The Glitch & The Fix, Sept 2016
© Copyright 2016, J. Siegenthaler
First serial rights granted to BNP Media, all other rights reserved

Following Instructions...

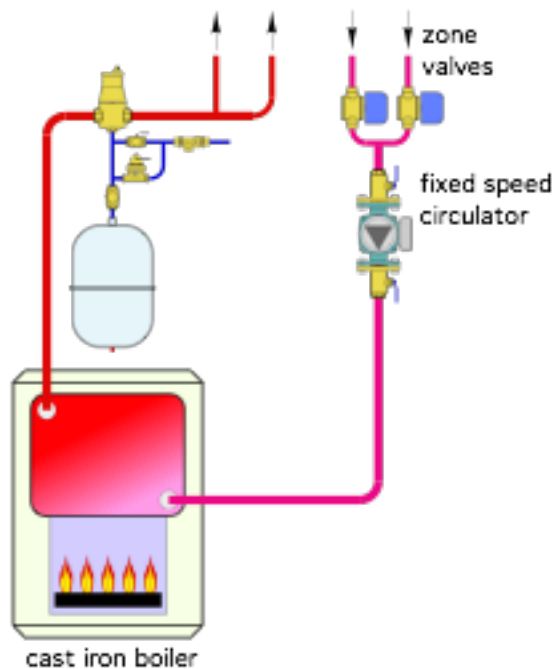
The schematic very similar to the one below appeared in a manufacturer's installation manual. It represented their recommendation for installing a two zone system. Can you identify at least five things that could be changed to improve this system?

1. The zone valves should be located on the supply side of the zone circuits to eliminate heat migration into inactive zone circuits.

2. The tee shown below the zone valves is a “bullhead” tee. When both zones are on, return flows slam directly into each other. This creates turbulence and noise. It also wastes circulator head.
3. There should be at least 12 diameters of straight pipe leading into the circulator. Placing it close to the side port of the bullhead tee allows turbulent flow into the circulator. This decreases circulator performance and creates noise.
4. The circulator in the glitch drawing is pumping *toward* rather than away from the expansion tank. This causes a decrease in pressure within the zone circuits when their circulators operate.
5. There is no provision for differential pressure control in the original system.
6. There are no purging valves in the original system.

These glitches have been corrected in the fix drawing.

Differential pressure control is managed by a pressure regulated variable speed circulator. It could also be managed by a differential pressure bypass valve in combination with a fixed speed circulator.
